# Stonnington Planning Scheme Amendment C276

## Improvement to Chapel Revision Planning Controls

Statement of Urban Design Evidence, by Craig Czarny of Hansen Partnership for the City of Stonnington  
October 2018

Diagram demonstrating consideration for topography in determining the preferred development scale along River Street

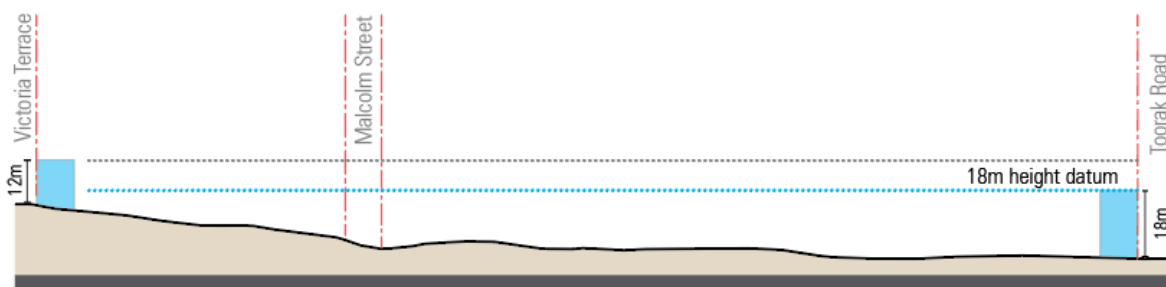
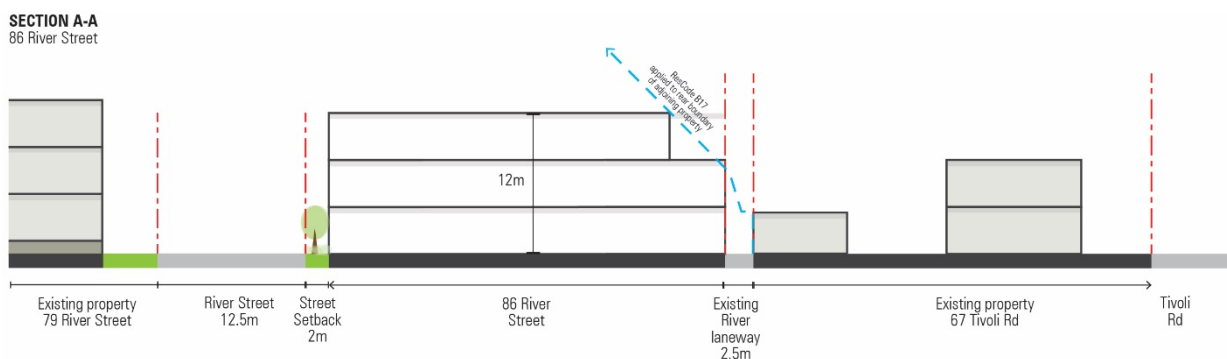
24. The northern part of River Street, between Malcolm Street and Victoria Terrace is proposed to have an adjusted 'preferred' building height of 3 storeys – reduced from the 5 storey designation introduced through Amendment C172. This adjustment is in my view warranted with respect to the necessary transitional role of the urban block from the west side of River Street (as built) to the more sensitive in NRZ and Heritage interface to the east in Tivoli Road. With the exception of the taller form addressing the corner of Malcolm and River Street (west side) at 16 storeys, most of River Street (west) is 'built out' with marginal setback and elevated apartment form of 3 and 4 storeys. While I accept that the conditions closer to the Malcolm Street junction are distinctive, I consider the street relationships to the north (uphill from 86 River Street) to be such that they deserve a corresponding approach. A height transition to 3 storeys on the eastern side of River Street, stepping down at River Lane to 2 storeys is in my view appropriate. A 12m measure is fitting as it corresponds to a 1:1 street width to street wall proportion identified elsewhere in Chapel reVision.

25. The land to the north of Malcolm Street is distinctive in that it is elevated leading to a local ridgeline marginally to the north of Victoria Terrace. At 3 storeys, the overall height of new development will be similar to that of 5 or 6 storeys form on lower land close to Toorak Road to the south. While I acknowledge that taller buildings in the foreground (exceeding the 5 storeys measure south of Malcolm Street) may obstruct such skyline views, I believe that there is logic in benching a height datum (such as a common AHD) along the length of the corridor, particularly as it approaches the local ridgeline.

Cross Section through River Street to Tivoli Road

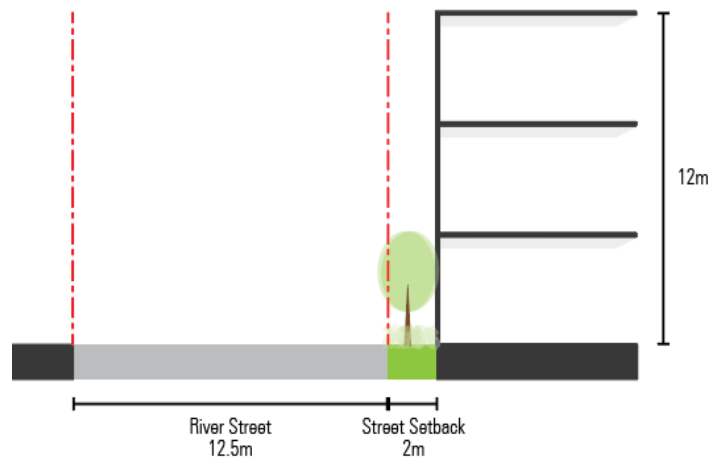
34. Amendment C276 seeks to introduce a new interface setback profile to properties on River Street to the north of Malcolm Street, with specific reference to the rear interface with River Lane and Tivoli Road properties in the NRZ and HO. The existing ACZ1 profile (Type 4) defines a 12m height with 45-degree setback profile above. The proposed arrangement acknowledges the sensitivity of the eastern properties – (all with the exception of the flats at 65 Tivoli Road are traditional double fronted detached dwellings) with a more conventional ResCode B17 profile.

35. This design response is only applicable in areas of sensitivity abutting the combined NRZ and HO and as a discretionary control would be evaluated on an individual or site by site basis. Given the revised overall 3 storey height parameter applicable to this precinct, it is in my view entirely appropriate to apply a marginal setback above 2 storeys to ensure matters of visual bulk are successfully managed. This measurement should be applied from the neighbour's rear boundary (east side of the Lane).

*Northern reaches of River Street with shallow front setbacks*

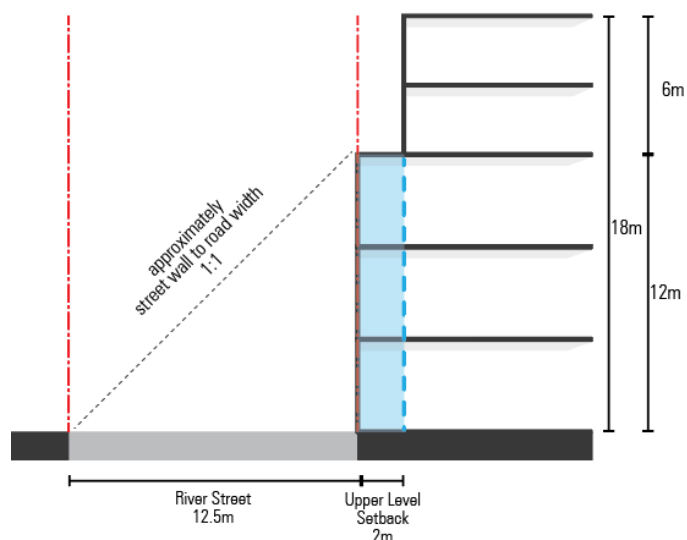
28. An inspection of the existing physical condition of parcels in the northern parts of River Street – in particular uphill of 86 River Street demonstrates a prevailing building setback condition. This 'domestic' presentation is viewed in concert with narrow frontages and attached cottage stock on the east side of River street, opposite 3-4 storey boxed apartment forms behind a landscaped ground level setback to the west. While the initial intention of the ACZ1 (as implemented through C172) was for a hard 'street wall' condition akin to a commercial profile, there is in my view warrant to adjust this design response to the upper reaches of River Street to reflect this predominantly local residential condition and the domestic language of the streetscape.

29. All buildings on either side of River Street in this locality have a front setback and exhibit what I consider to be a domestic address. Whilst some of properties have more substantial setbacks of 5m or more, I believe that it is appropriate to this street edge to establish a baseline setback (as recommended) of 2m to support low-level landscape and a green fringe to the street frontage. This can also ably assist in managing access and a sense of address on sloping land, which is a relevant consideration in this part of River Street.
